**APPLICATION TO MODIFY DEVELOPMENT CONSENT,
SECTION 4.55(2) ENVIRONMENTAL PLANNING & ASSESSMENT ACT**

Development Application No: DA2024/0004

Premises: Lot 22 DP 7022
31 Kooloora Avenue, Freshwater 2096

Proposed Development: Demolition works and construction of a dwelling house

Figure 1: Small variation to the height of buildings of the modified works is circled in red

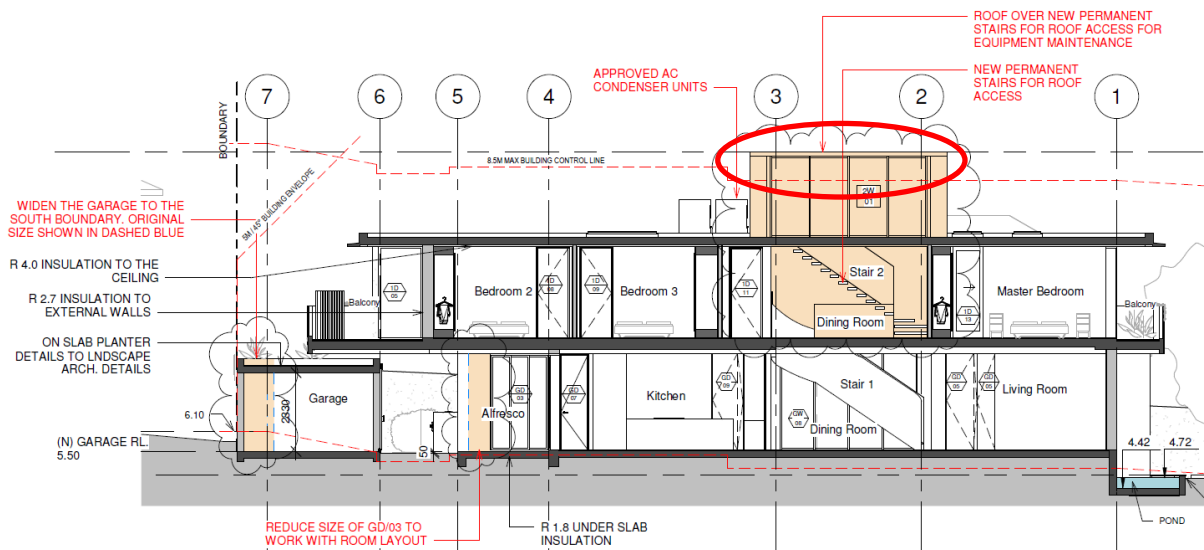
The building height limit for development in this portion of Freshwater is 8.5m. The modified dwelling will maintain a maximum height of approximately 9.32m and therefore demonstrates a minor variation of 0.82m to the maximum building height and will exceed the approved height by 1.42m.

The majority of the previously approved roofline is maintained at RL11.95, with only the roofline over the internal access stairs to be raised to RL 14.35 (See Figure 1 below).

When using the ground floor level as the reference point for the 8.5m height control under Warringah Local Environmental Plan 2011, the proposed works result in a minor exceedance, reaching a maximum height of 9.32m. This variation occurs over a limited length of approximately 5m and is associated solely with the addition of internal stairs providing access to the roof for ongoing maintenance purposes. The
